MISSISSIPPI POWER & LIGHT COMPANY

June 21, 1984

SUBJECT: Grand Gulf Nuclear Station
Unit 1
Docket No. 50-416
License No. NPF-13
File 0260/0840/L-860.0
Proposed Amendment to the
Operating License
(PCOL's-84/09, 13C, and
14B)
AECM-84/0318

Figure 3.2.1-1

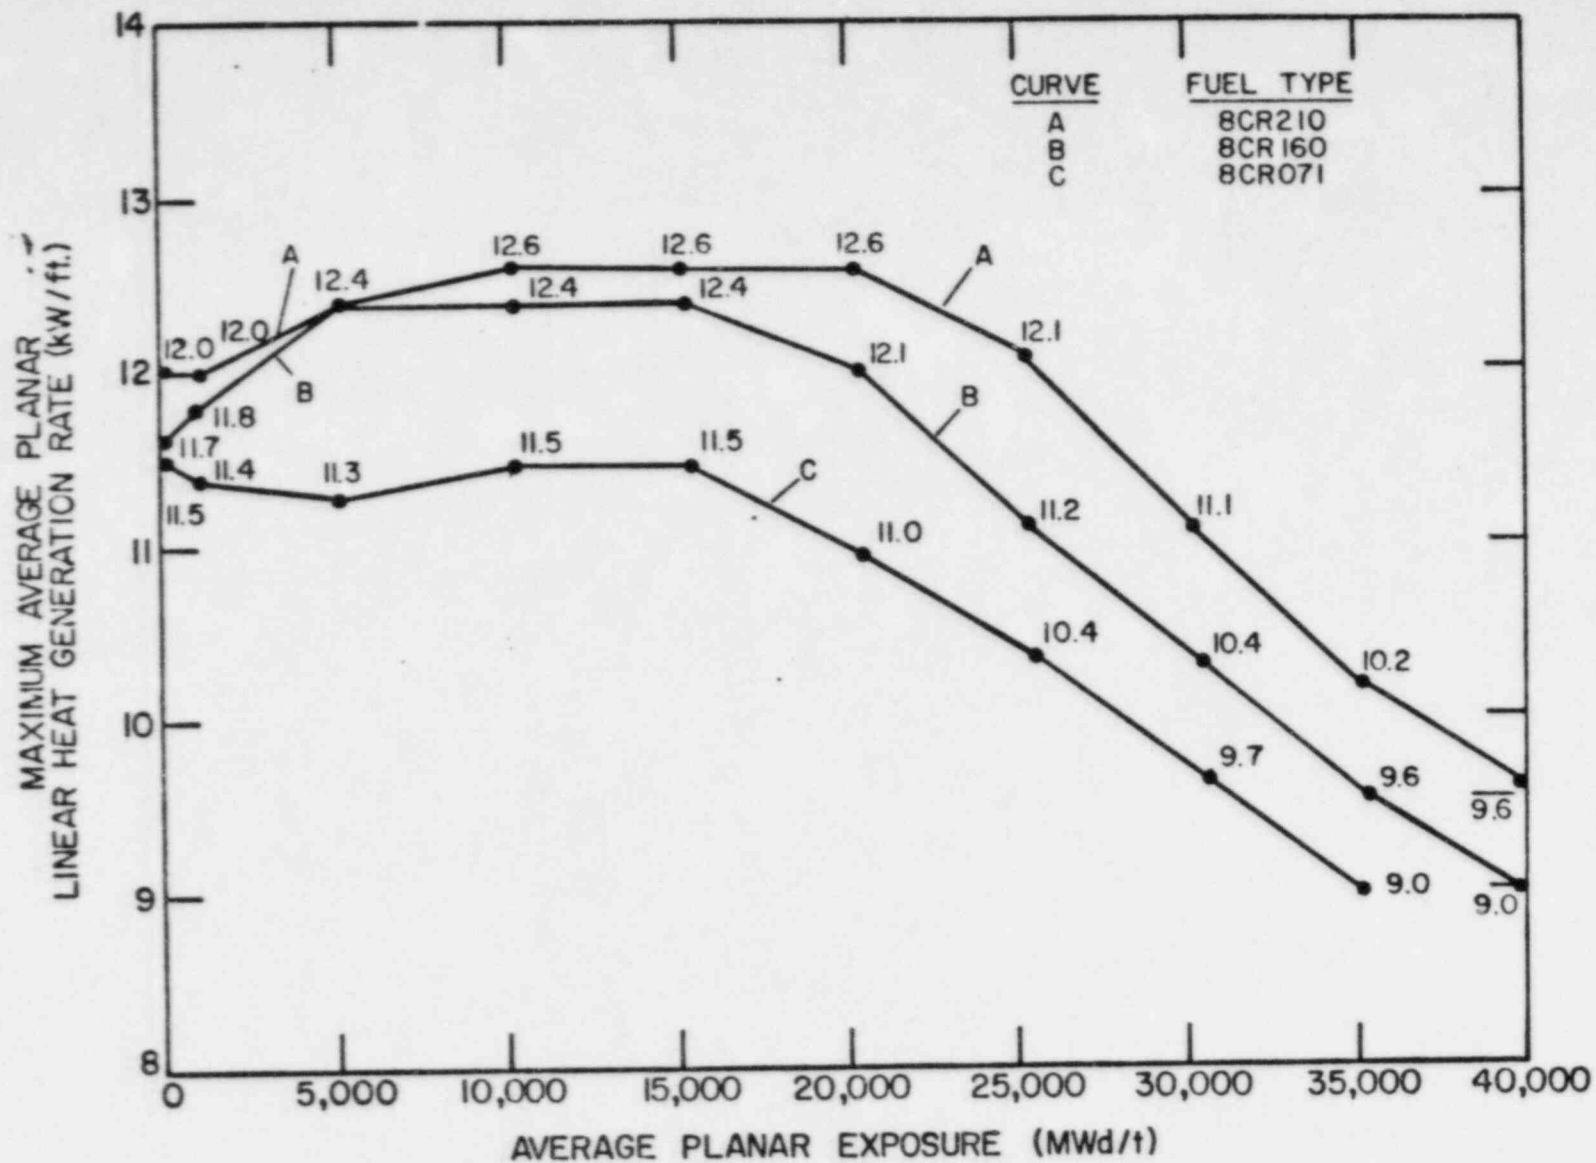
Legible copies of the subject figures are submitted to replace the figures currently found in the technical specifications. The subject figures have been redrawn to show only the major chart divisions, to utilize more legible font, and to clearly identify areas of acceptable and unacceptable operation, where applicable. The MAPLHGR graphs for the three anticipated fuel types (Figures 3.2.1-1, 3.2.1-2, and 3.2.1-3) have been incorporated into a single figure (3.2.1-1). Specification 3/4.2.1 is revised to refer to only this figure. The "75% Rod Line" and the "Maximum Flow Control Line for Transfer to 100% Speed" are added to Figure B 3/4.2.3-1 for enhancement. Neither the limits of operation or scale ranges of the figures are affected by this submittal. This is an administrative change that enhances the readability of the technical specifications, and is submitted in response to NRC requests. (Pages 3/4 1-20, 3/4 2-1, 3/4 2-2, 3/4 2-3, 3/4 2-4, 3/4 2-7, 3/4 2-8, B 3/4 2-5, B 3/4 3-7 and B 3/4 4-7)

Figure B 3/4 2.3-1

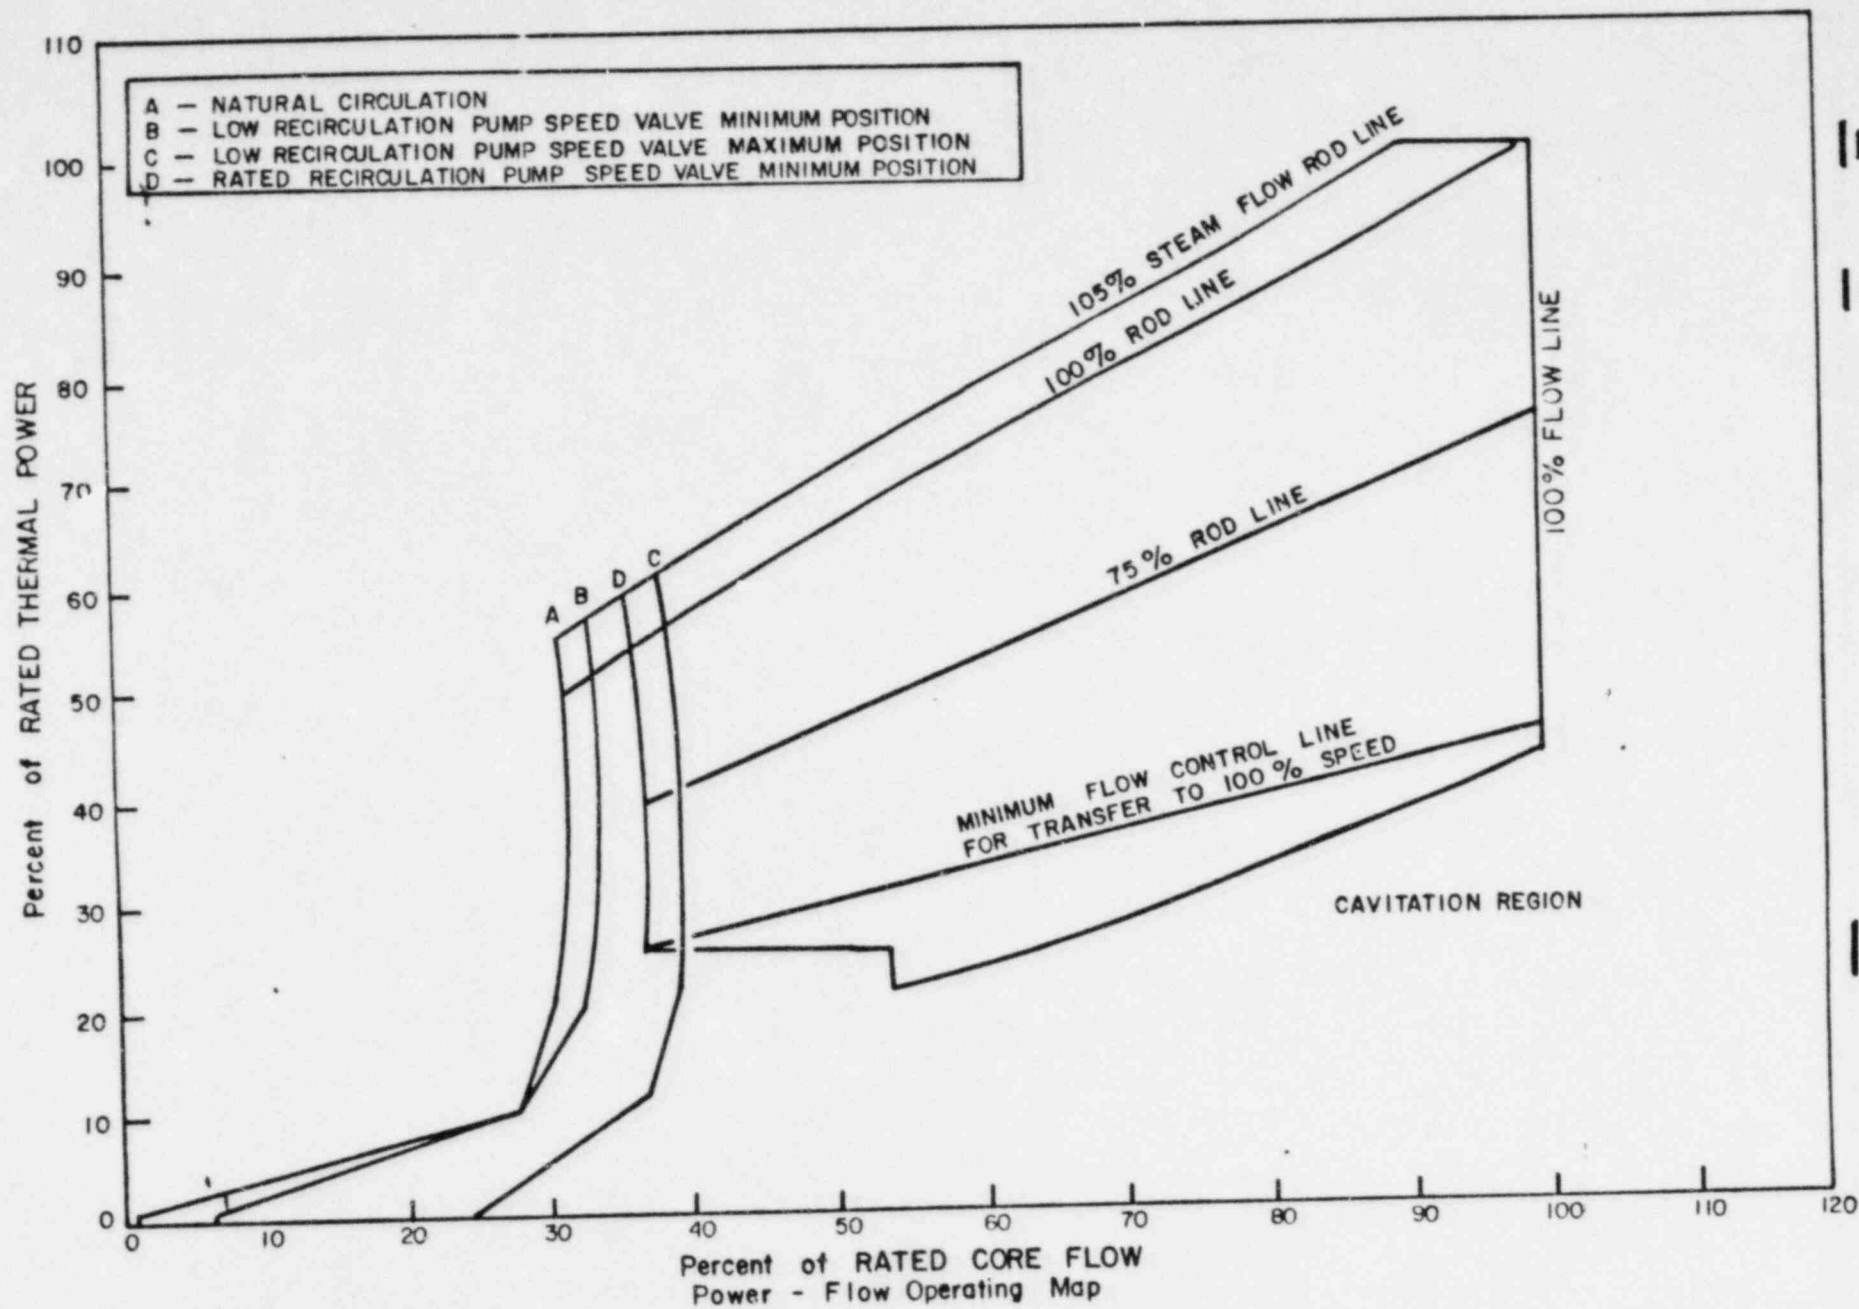
neutron flux oscillations could create the potential for portions of the core to operate outside the limits of the power/flow operating map of Figure B 3/4 2.3-1. Reduction in reactor power to 80% of that specified by the 100% rod line provides assurance that local power/flow conditions will remain within the operating limits established by the plant safety analysis. This change is a result of recent NRC guidance to avoid high power/low flow core regions in the event of the loss of one or more recirculation loops. Therefore, the proposed change represents an enhancement to plant safety since it imposes more stringent restrictions on plant operation than those contained in the current specification. (Page 3/4 4-1)
